#### SHEET DATE OF CHANGE ECO NO. REQUESTED BY ENGINEERING CHANGE ORDER ΩF 11 PREMIER AVIATION, INC. 2621 AVIATION PARKWAY, GRAND PRAIRIE, TX 75052 FSCM - OSUV8 **ENGINEERING** ECO 5471 STC(s) AFFECTED: SH8443SW FAA SUBMITTAL **APPROVALS** YES NO PREPARED BY DATE 03/19/98 C.R.SHORT REASON FOR CHANGE DOCUMENT AFFECTED CHECKED DATE FACILITATE FAB. DESIGN ERROR REVISION 4/6/98 CUSTOMER CHANGE DRAFTING ERROR NUMBER IS WAS DATE QUALIT DESIGN CHANGE ADDITION DESIGN INFO C C 10/19/94 B64-13021 BLEED AIR ECU OTHER TITLE DUCT ROUTING TYPE CLASSIFICATION INCORPORATED RECORD PMA MINOR TSO MINOR 400 UNINCORPORATED STC IPMA MAJOR TSO MAJOR (NOTE TO INCORPORATOR: USE NEXT AVAILABLE DESCRIPTION: NOTE NUMBER UPON INCORPORATION) PARTS LIST: SHEET 1 NOTES: ADD PERMISSIBLE TO SUBSTITUTE EQUIVALENT AN960 WASHER ADD -31 AND -73 ASSY FOR NASI149 WASHER UNTIL CURRENT STOCK IS DEPLETED. - 73 DUCT MODIFICATION REFERENCE NASI149 SPECIFICATION FOR SUBSTITUTION TABLE. - 31 DUCT VALVE ASSY DIMPLE INSIDE OF DUCT AS REQUIRED WAS FOR FLUSH FIT OF MS24694-S68 SCREW. -07 DUCT MODIFICATION 1 ASSY -03 AND -07 ARE NOT AVAILABLE FOR NEW DESIGNS AS OF 19 MARCH 1998. USE -31 AND -73 <u>|S</u> ASSY FOR NEW PRODUCTIONS. 1

DESCRIPTION: SHEET 1 ZONE 7A

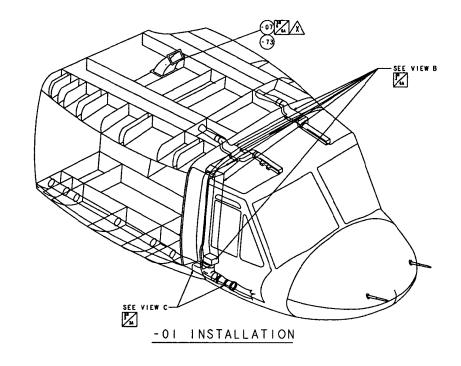
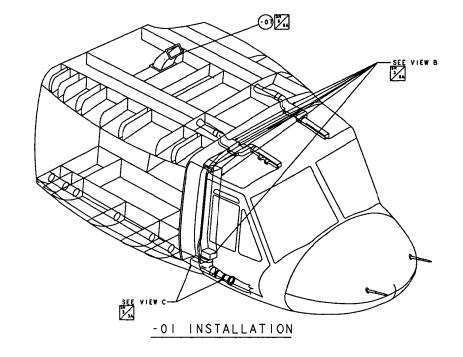
"IS"

"WAS"

SHEET 3 ZONE 3A "IS"

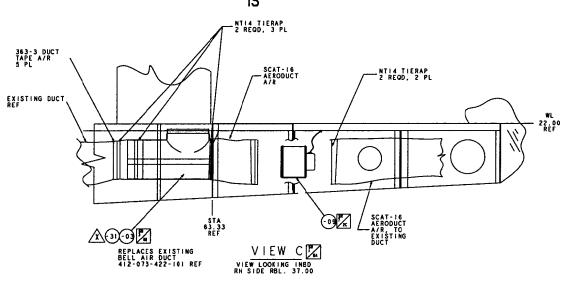
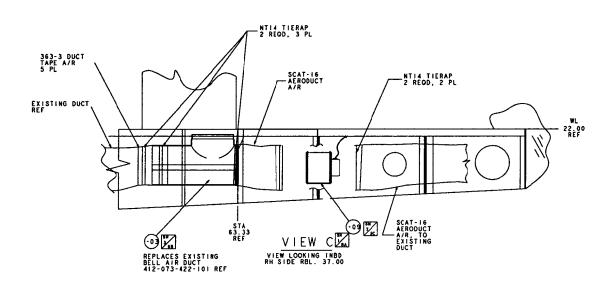
"WAS"

DESCRIPTION: ADD -73

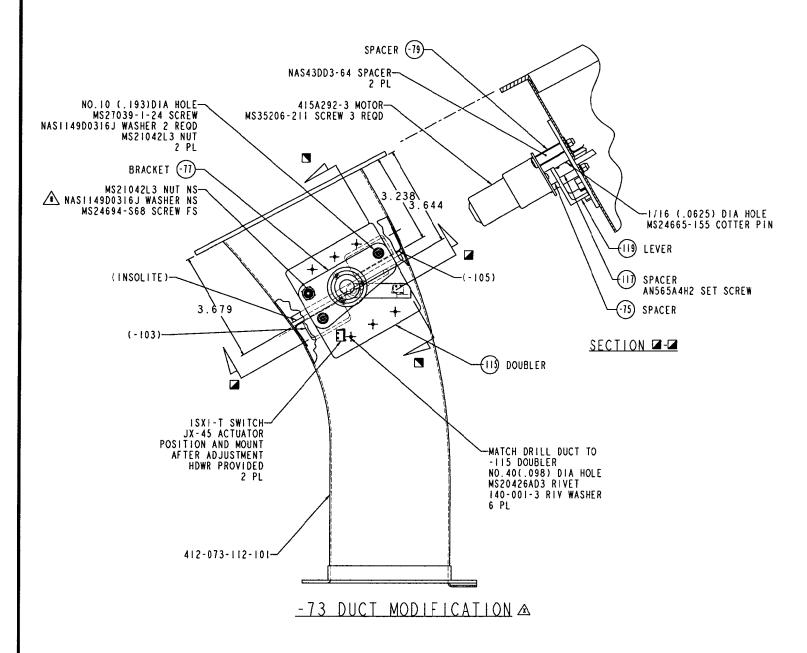
(NOTE TO INCORPORATOR: USE NEXT AVAILABLE SECTION LETTER UPON INCORPORATION)

DESCRIPTION: ADD DETAILS -75, -77, AND -79

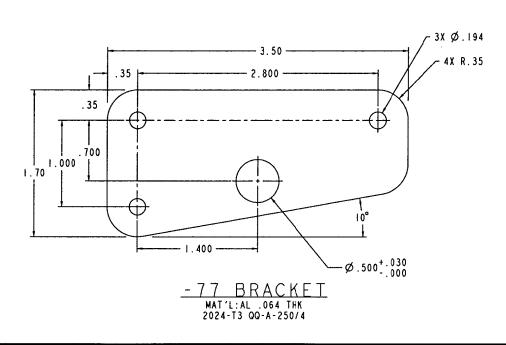
-75 SPACER MAT'L: AL .500 DIA BAR 2024-T3 QQ-A-200/3

-79 SPACER MAT'L: AL .375 SQ BAR 2024-T3 QQ-A-200/3

DESCRIPTION: ADD DETAILS -109 AND -111

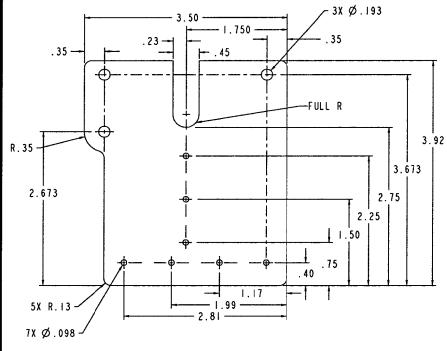
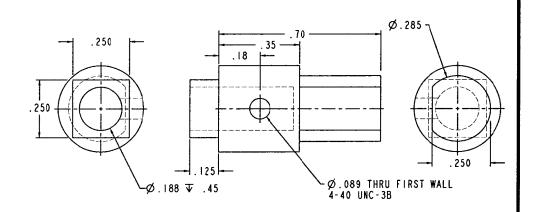
- 109 BRACKFT MAT'L: AL .032 THK

- | | SPACER MAT'L: .375 DIA BAR 2024-13 00-A-200/3

DESCRIPTION: ADD DETAILS -113 AND -115

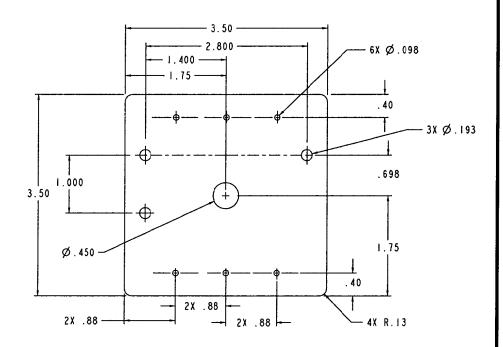
-113 SPACER

- | 15 DOUBLER MAT'L: AL .125 THK 2024-T3,00-A-250/4

DESCRIPTION: ADD DETAILS -117 AND -119

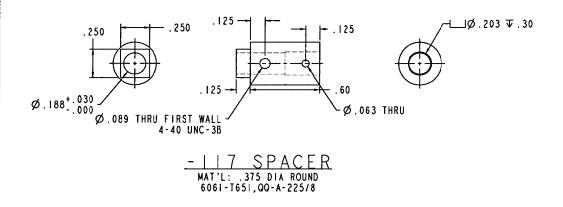
- 1 1 9 LEVER MAT'L: ANDIO134-1002 2024-T3511,QQ-A-200/3
